CONCEPT DEVELOPMENT PLAN
BOONE COUNTY PLANNING COMMISSION

## STAFF REPORT

Request of **Meijer, Inc. (owner)** for a Change in Concept Development Plan in an Office Two/Commercial Two/Planned Development (O-2/C-2/PD) zone at 4990 Houston Road, Florence, Kentucky. The request is for a change in an approved Concept Development Plan to permit a freestanding convenience store with retail fuel sales.

September 23, 1998

FIGURE 2  
SITE PLAN

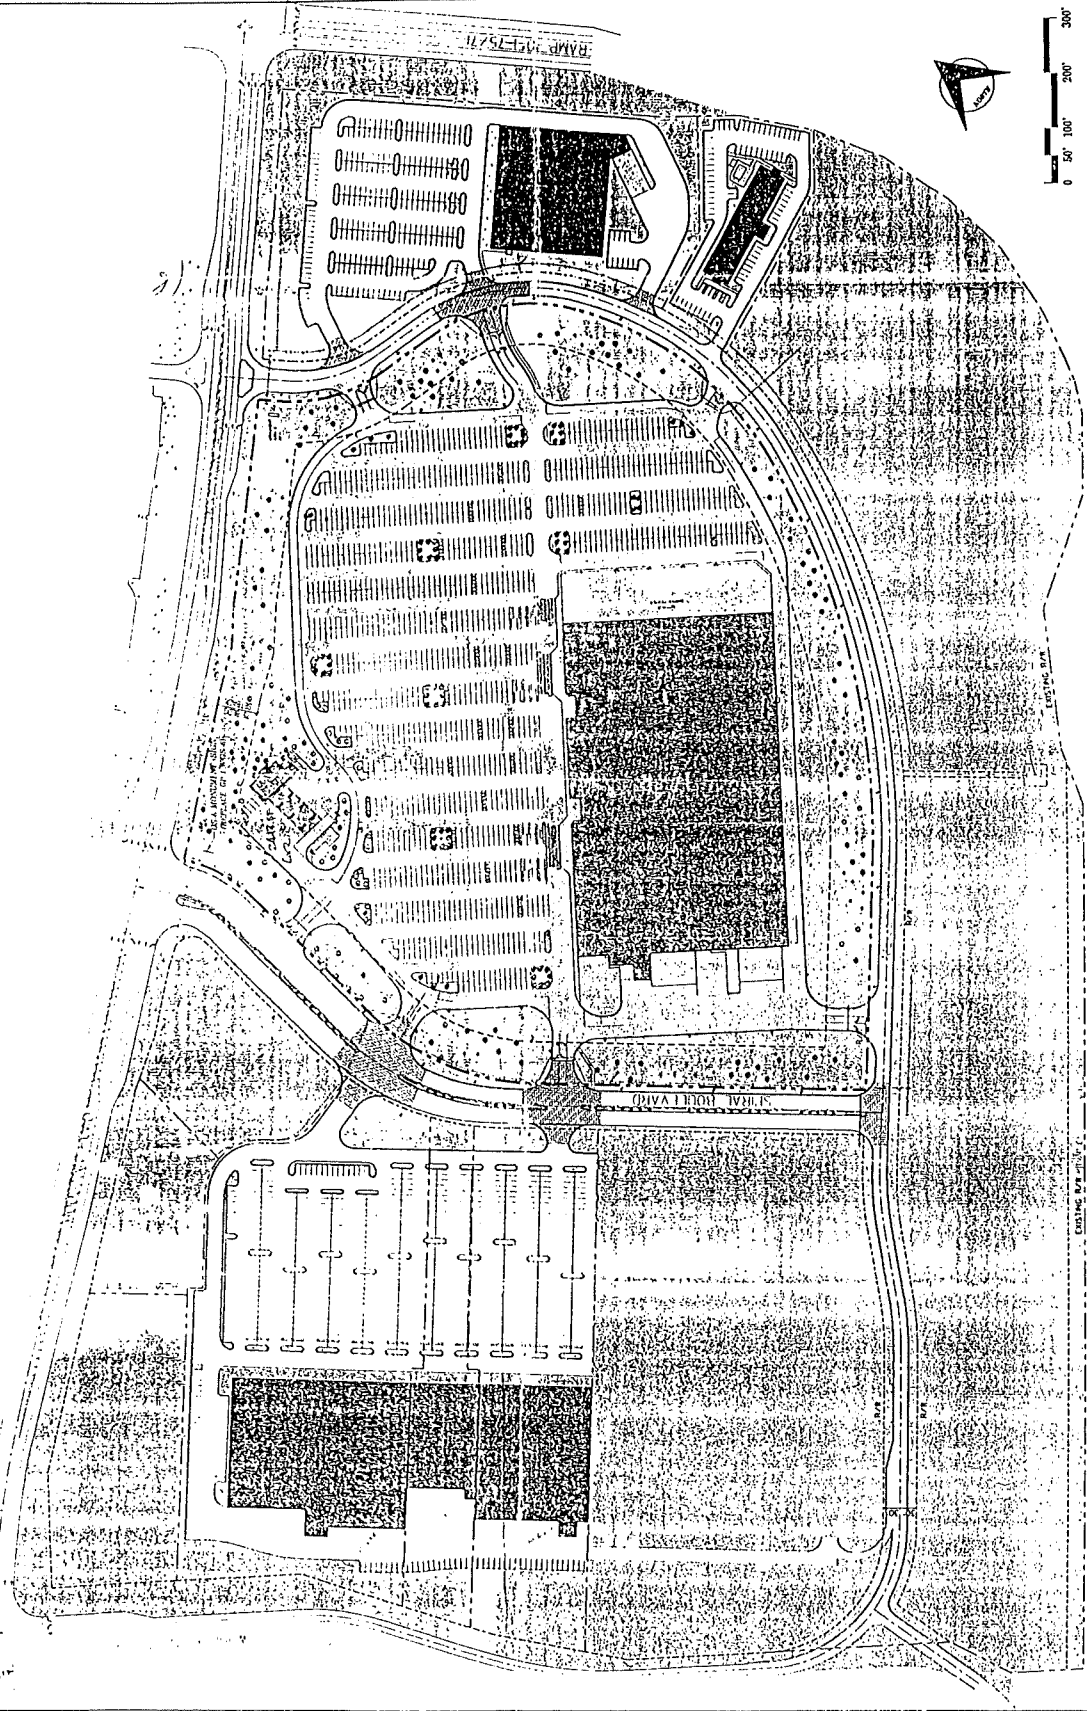
Staff contends that if the proposed facility is truly intended to serve customers already patronizing the Meijer store, it could be moved much closer to the Meijer building and away from the street frontages, especially the intersection itself. Staff also poses the question that if this proposal were to be approved, will the other approved outlot uses on the Meijer tract be abandoned? Three outlot uses were approved on the original Concept Development Plan.

4. Staff has the following general issues regarding the proposal.
  - A. The "Blue Rhino Propane" shown on the landscape plan needs to be explained. If this is some sort of propane dispenser (such as the kerosene dispenser shown on the plan) or rack for propane containers, the Commission will need to evaluate the appropriateness of outdoor propane and kerosene sales/storage, much like the outdoor storage/display of seasonal merchandise discussed previously.

- B. Based on the requirements of Article 33 of the Boone County Zoning Regulations, at least sixteen parking spaces must be provided for the project. A total of seven parking spaces are shown on the Concept Development Plan.

Mr. Fossett asked Mr. Kinsel to address Staff's comment that there were not enough parking spaces. Mr. Kinsel stated that 16 spaces are required and they are only showing seven -- but there are 12 fueling stations that would act as parking spaces. He stated that the majority of the guests who use the convenience store do so after they fill up their car at the pump. He stated that there are 19 parking spaces within the site and, if needed, they also have all of the parking on the Meijer lot.

Mr. Fossett asked Mr. Kinsel to comment regarding the sidewalk and the bike rack. Mr. Kinsel stated that they have no problem with a sidewalk to the roadway and a bike rack at the facility.
